PG&E Letter DCL-11-097

Diablo Canyon Units 1 and 2
Docket No. 50-275, OL-DPR-80
Docket No. 50-323, OL-DPR-82
License Amendment Request 11-05, "Evaluation Process for New Seismic Information and Clarifying the Diablo Canyon Power Plant Safe Shutdown Earthquake"

Evaluation of the Proposed Change

FSAR UPDATE
UNITS 1 AND 2 **DIABLO CANYON SITE**
FIGURE 3.7-33 LTSP Evaluation Process for Plant Additions and Modifications

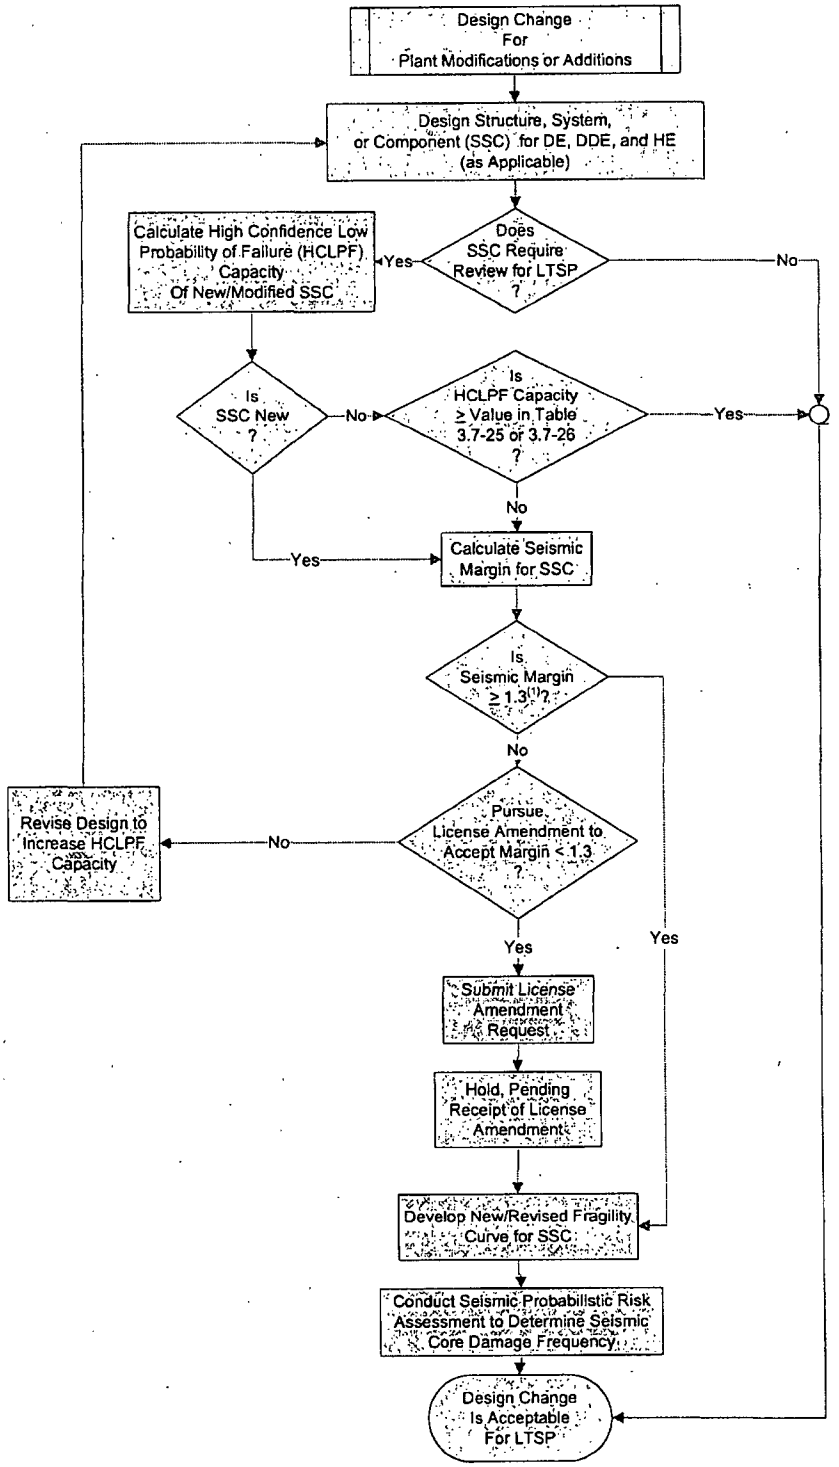
The following provides a summary of the key steps of the LTSP evaluation process applied to additions and modifications to DCPP structures, systems, and components. An overview of the LTSP evaluation process is shown in Figure 3.7-33.
